**PLANNED UNIT DEVELOPMENT  
& SUBDIVISION STAFF REPORT****Date: April 3, 2014****DEVELOPMENT NAME**

First Baptist Church of Tillman's Corner Subdivision

**CONTEMPLATED USE**

Planned Unit Development to allow multiple buildings on a single building site and Subdivision approval to combine multiple lots to create one legal lot of record.

## SITE PLAN

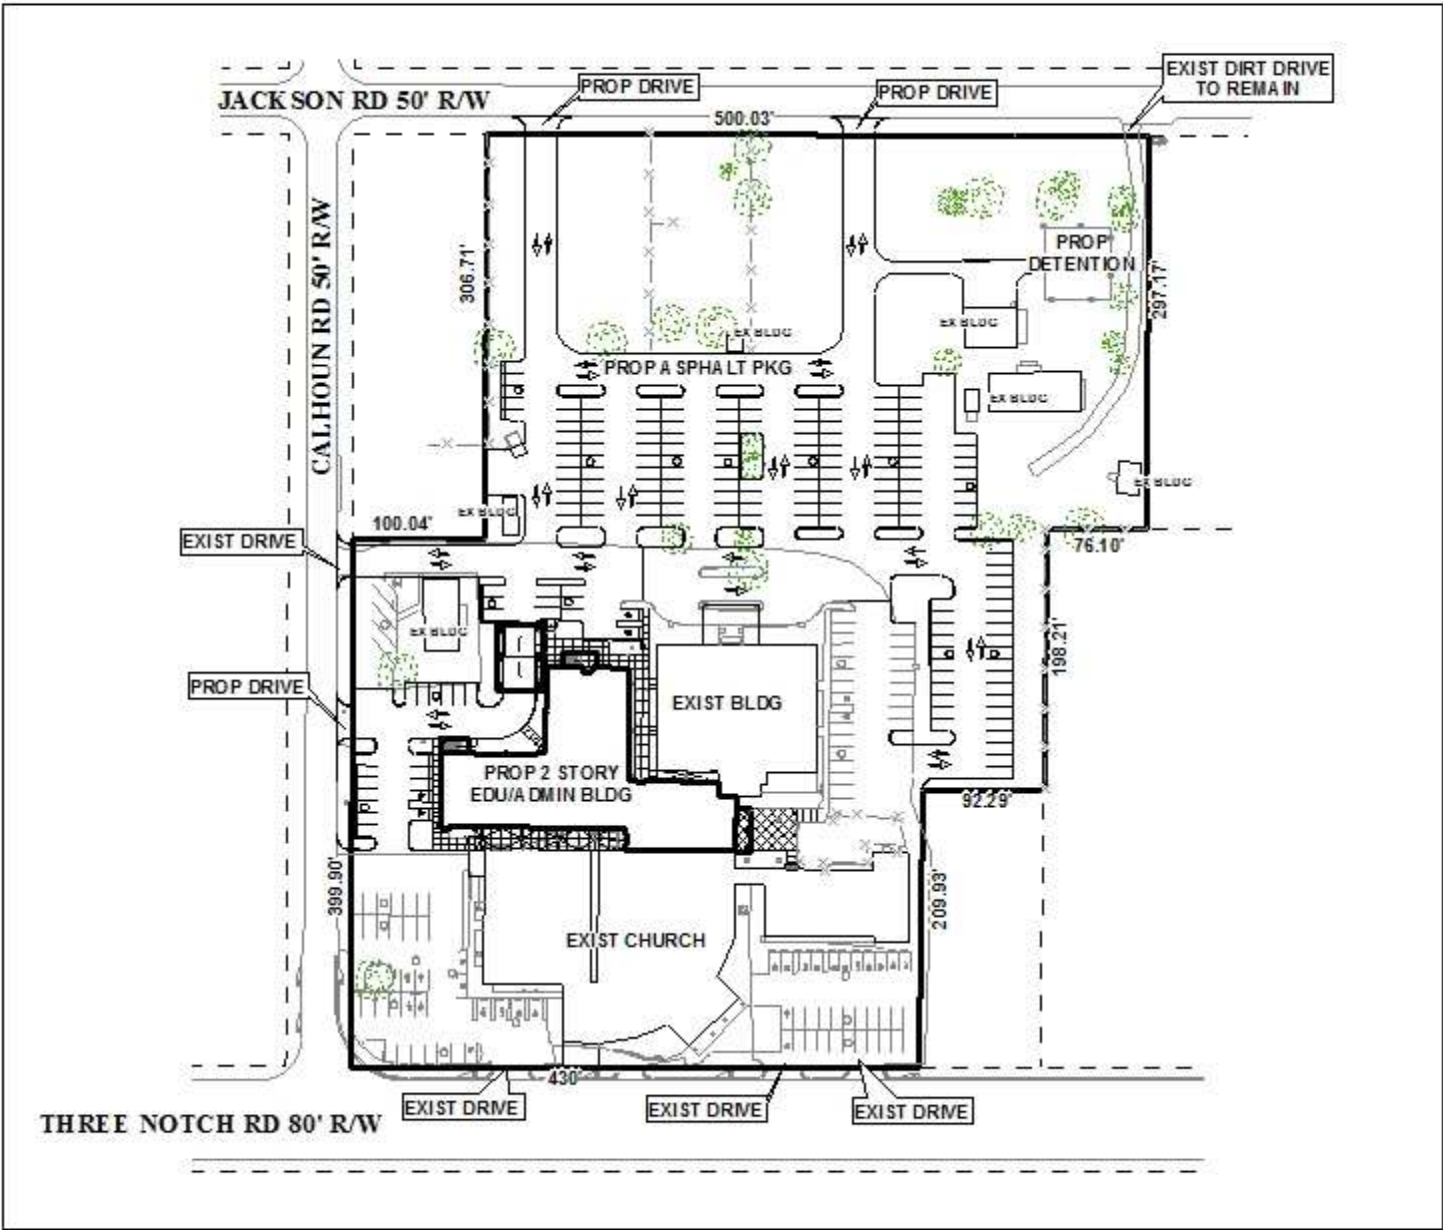
Calhoun Road must be reduced in width, by maintaining the proposed northern radii and moving the southern radii to match the adjacent aisle width. All new on-site parking, including ADA handicap spaces, shall meet the minimum standards as defined in Section 64-6 of the City's Zoning Ordinance.

Access management is a concern due to the site's fronting 3 streets with multiple curb-cuts and existing substandard vehicle maneuverability areas. The site has 13 existing curb-cuts and as the applicant proposes to improve access, 10 curb-cuts will still remain. The southern lot line, which runs along Three Notch Road, has 4 curb-cuts and the western lot line along Calhoun Road has 3 curb-cuts, one of which appears to be over 75'  $\pm$  wide. The curb-cuts access existing and proposed parking area. It should be pointed out that some of the existing travel aisles measure only 9'  $\pm$  and, as such, Staff recommends a one-way traffic circulation if the existing parking areas are remain non-compliant. Jackson Road has 6 existing, substandard curb-cuts. The applicant proposes to eliminate 3 and retain and improve 2 of the curb-cuts. As one of the gravel drives appears to remain unimproved, the site plan should be revised to illustrate a paved drive.

The site plan illustrates several existing issues within the site. A portion of the eastern property line north of Three Notch Road appears to share access with the adjacent lot to the east, which is not included in this request. The site plan should be revised to illustrate curbing and landscaping along the eastern property line to prevent vehicular access between the two lots. If the applicant desires to continue a shared access, the lot to the east should be included in the PUD request.

All proposed parking areas appear to be compliant in terms of travel aisle width and parking stall dimensions; however, the site plan does not depict any proposed lighting. Any new lighting on the site will have to comply with the requirements of Sections 64-4.A.2., 64-6.A.3.c., and 64-6.A.8. of the Zoning Ordinance. A note reflecting this requirement should appear on the site plan, and photometric plans will be required at the time of permitting.

It should be pointed out that the site plan does not depict any sidewalks along any street frontages. The site plan should be revised to illustrate sidewalks along all street frontages or the applicant should submit a Sidewalk Waiver request.

Also, the site plan does not depict a residential buffer nor frontage trees and landscaping. A 10' residential buffer should be required along the northwestern lot line where the property abuts an adjacent residentially developed lot and along the northeastern lot line where the property abuts a vacant lot which may be developed residentially. The site plan should be revised to illustrate the buffer in compliance with Section 64-4.D.1. of the Zoning Ordinance and illustrate and quantify full compliance with the tree and landscaping requirements of Section 64-4.E. of the Zoning Ordinance.

The site plan depicts a dumpster and it should be noted that all dumpsters shall be in compliance with Section 64-4.D.9. of the Zoning Ordinance to include being enclosed on at least three sides and connected to sanitary sewer.

- 1) Provision of a written statement that the owner will petition for inclusion or exclusion from the city;
- 2) Revision of the site plan to depict a permanent closure of the vehicular access to the adjacent property to the east with curb and landscaping, or the revision of the PUD request to include the lot to the east and shared access;

- 3) Revision of the site plan to comply with Traffic Engineering Comments: *(Driveway number, size, location and design to be approved by Traffic Engineering and conform to AASHTO standards. The southern most driveway on Calhoun Road must be reduced in width, by maintaining the proposed northern radii and moving the southern radii to match the adjacent aisle width. All new on-site parking, including ADA handicap spaces, shall meet the minimum standards as defined in Section 64-6 of the City's Zoning Ordinance.);*

- 4) Coordination with Staff to improve onsite traffic flow and revision of the site plan to illustrate one-way traffic flow with compliant 12' travel aisles/vehicular maneuverability area where travel aisles are less than 24';

- 5) Revision of the site plan to illustrate proposed lighting along with a note stating any new lighting on the site will have to comply with the requirements of Sections 64-4.A.2., 64-6.A.3.c., and 64-6.A.8. of the Zoning Ordinance;

- 6) Depiction of a paved driveway in the northeast corner of the lot if the applicant desires to retain the curb-cut;
- 7) Depiction of sidewalks on the site plan along all street frontages or the submission of a Sidewalk Waiver request;

- 8) Depiction of a 10' residential buffer on the site plan along the northeastern and northwestern lot lines in compliance with Section 64-4.D.1. of the Zoning Ordinance;

- 9) Revision of the site plan to illustrate and quantify full compliance with the tree and landscaping requirements of Section 64-4.E. of the Zoning Ordinance;

- 10) Revision of the site plan to include a note stating that all common and detention areas shall be maintained by the property owners;
- 11) Revision of the site plan to reflect sufficient dedication to provide 30' as measured from the centerline of both Calhoun and Jackson Roads;

- 12) Revision of the site plan to depict a corner radius in compliance with Section V.D.6. of the Subdivision at the intersection of Calhoun and Three Notch Roads;

- 13) Revision of the 25' minimum building setback line on the site plan to reflect dedication and corner radius;
- 14) Revision of the site plan to depict a 35' minimum building setback line along Three Notch Road; and

- 15) Depiction of a dumpster on the site plan in compliance with Section 64-4.D.9. of the Zoning Ordinance.
